# Program Bulletin

## CUSTOMER SATISFACTION PROGRAM

**SUBJECT:** Liftgate Strut Rod Detaches

**MODELS:** 2010-2015 Cadillac SRX  
2011-2015 Chevrolet Volt

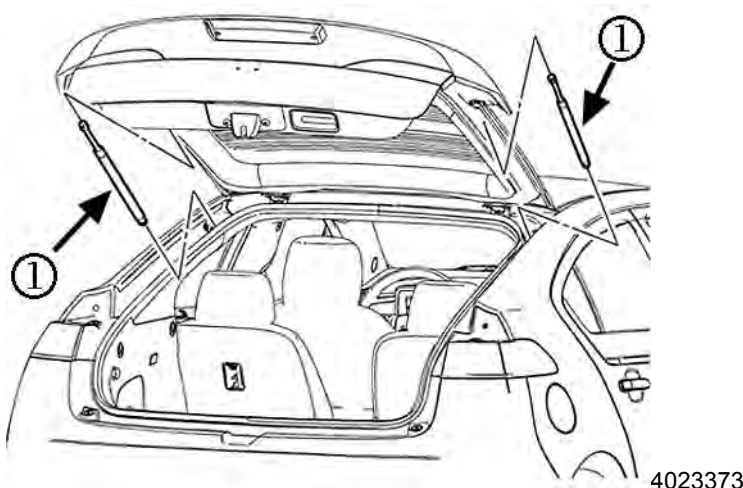
On certain 2010-2015 model year Cadillac SRX and 2011-2015 model year Chevrolet Volt vehicles, the manual liftgate gas strut may detach from the liftgate when the liftgate is closed and the piston rod could separate from the strut tube. If this occurs, the liftgate will not work and there may be damage to the liftgate exterior trim and sheet metal.

1. Remove the affected liftgate strut assembly (1). Refer to *Liftgate Strut Replacement* in SI.
2. Install the new liftgate strut assembly. Refer to *Liftgate Strut Replacement* in SI.

Dealers are to replace the liftgate struts.
